# Subdivision Staff Report

<b>Subdivision Name</b>	Plano Road Subdivision	<b>File Number</b>	SUB07-00065
<b>Approval</b>	Preliminary Plat	<b>Lead Agency</b>	Boise City
<b>Annexation Date</b>	Pending (CAR07-00042/DA)	<b>Comp. Plan</b>	<i>Does Not Comply</i>
<b>Public Hearing Date</b>	December 9, 2008	<b>Heard by</b>	Planning and Zoning Commission
<b>Planning and Zoning Commission Denial</b>	August 11, 2008	<b>Analyst</b>	Todd Tucker

PRELIMINARY PLAT

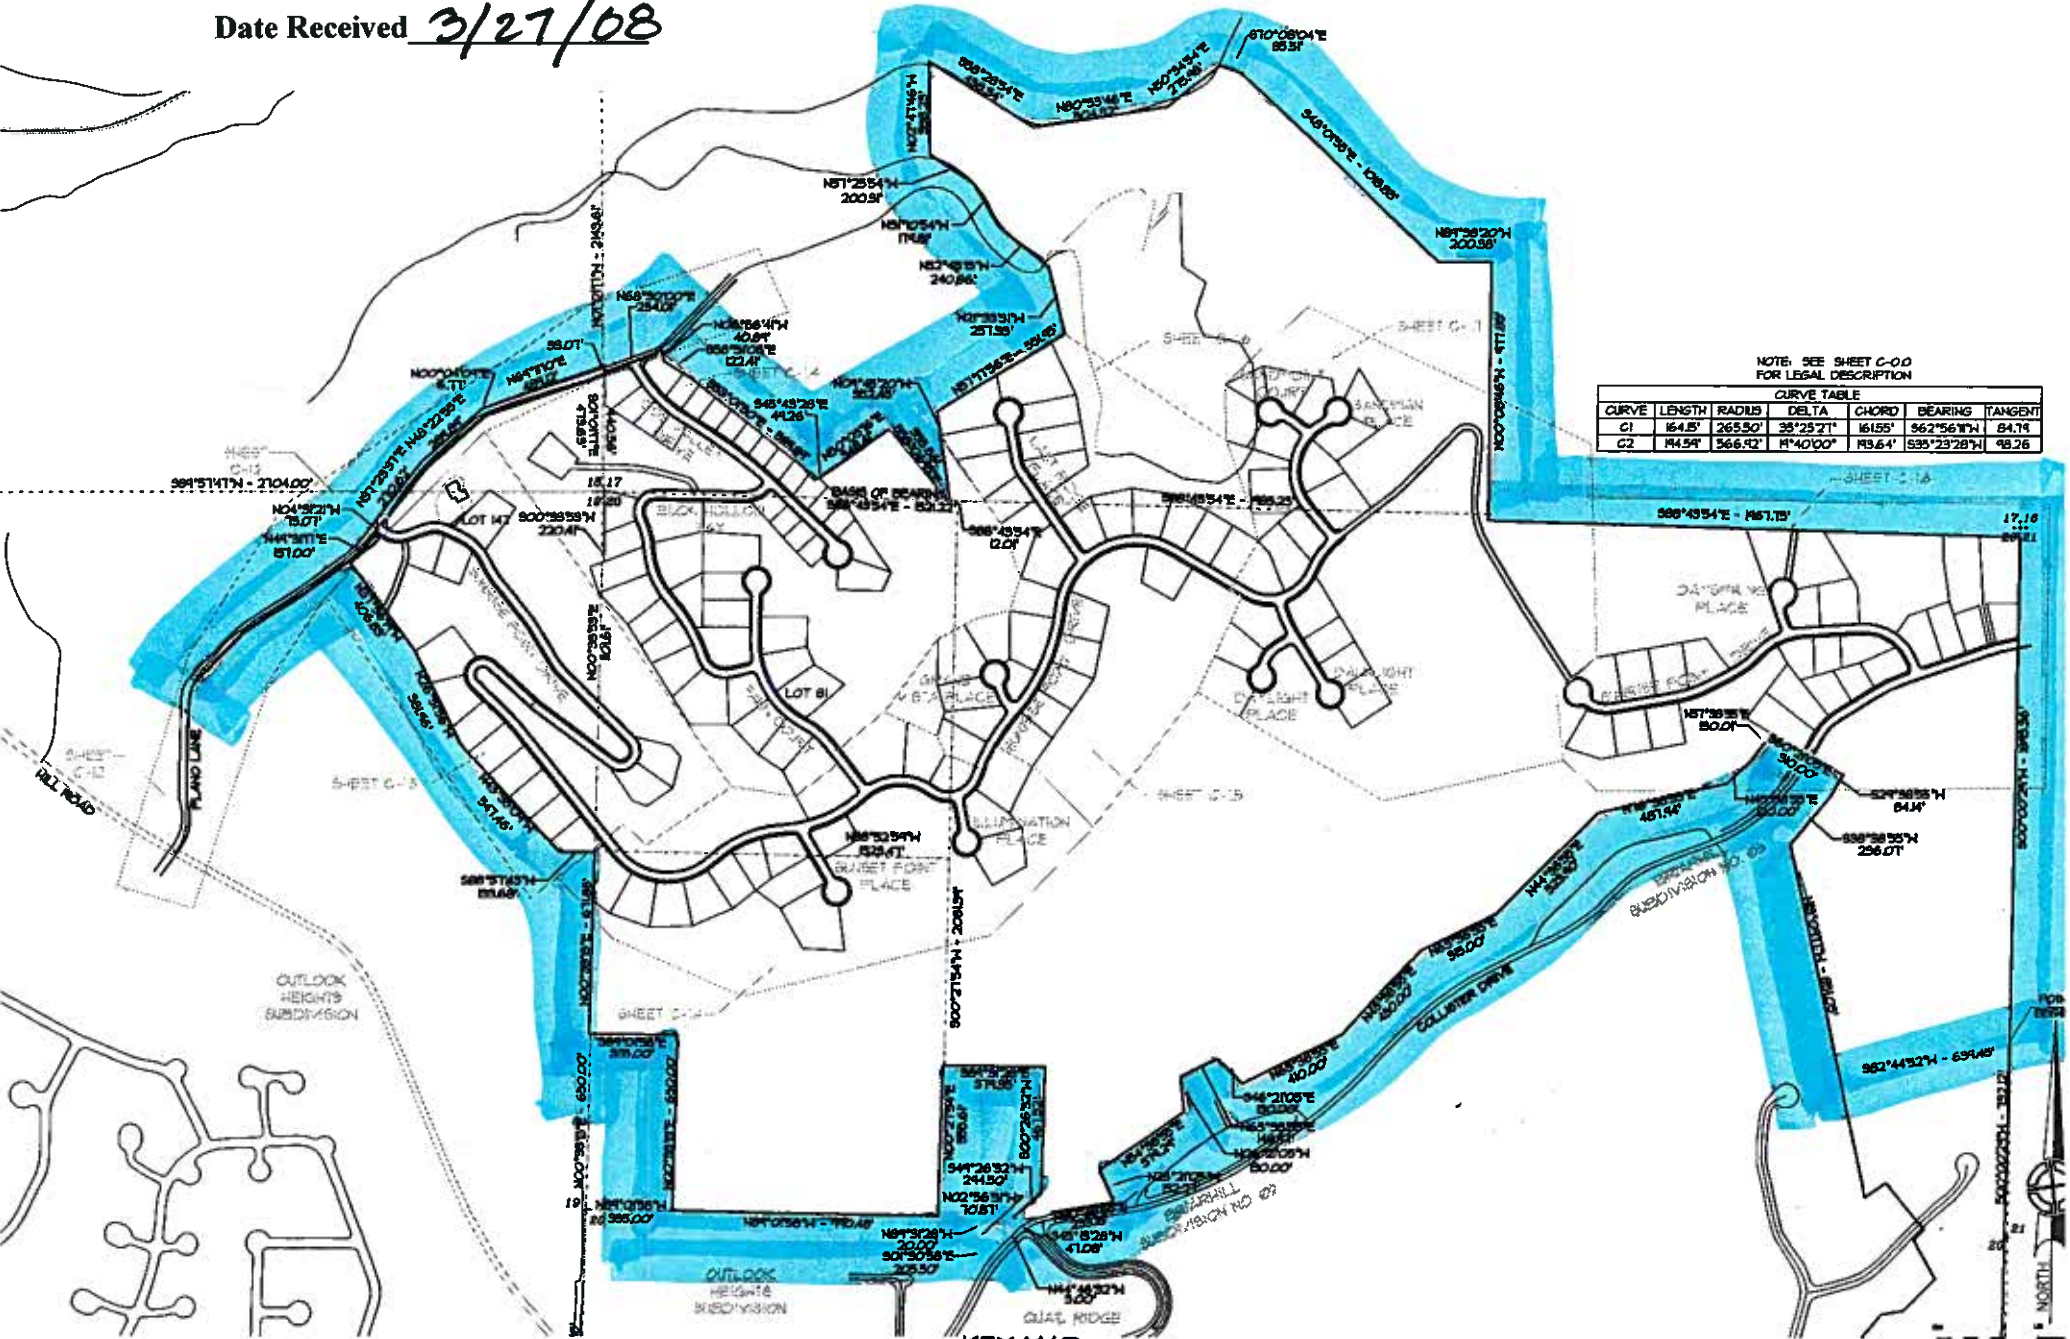
No fire hydrants have been noted. In the absence of information on existing hydrants it appears that many new hydrants may/will be needed. However, we reserve the right to modify requirements as more information comes to light. Variables affecting hydrant numbers and location include, but are not limited to, area, construction type, existing hydrants, accuracy of information provided in the application, strategic location for fire fighting forces, and required fire flow. New hydrants must be "non-private" installations.

**Staff Comment/Recommendation:** The topography of the site presents a challenge in ensuring compliance with District policy 7204.4 for local street design. The applicant's current plans propose five curves with centerline radii less than 100-feet (two on Daylight Rim Drive, three on Dawnbreak Place), and one set of reverse curves with a tangent length of less than 50-feet between them (on Daylight Rim Drive). The applicant will likely also need a variance for a centerline curve radius of less than 100-feet if it is to be a continuous public street as recommended.

- The plans for the Plano Road Subdivision show all streets ending in cul-de-sacs, with no connectivity to other surrounding streets. In order to furnish safe school bus turn-around locations to accommodate students living in the Subdivision, The Boise School District would like to see the cul-de-sac at the end of Sunrose Point Drive and the cul-de-sac at the end of Sandman Place both be marked with signage that says “No Parking – School Bus Turn Around”.

District staff recommends a modification of policy to allow the five curves with centerline radii less than 100-feet, the one centerline tangent length between reverse curves of less than 50-feet, provided all internal roadways meet AASHTO standards for a 20 MPH design speed. District staff recommends against any modification of policy to allow any centerline grade in excess of 10%.

15. Install intersection advisory signs on the eastbound approach of Hill Road west of the Hill Road – Plano Lane intersection.
16. Construct and dedicate all internal streets as 29-foot street sections (back-of-curb to back-of-curb) with vertical curb and gutter on both sides, and continuous 5-foot concrete sidewalk on one side, all within 40-feet of right-of-way.
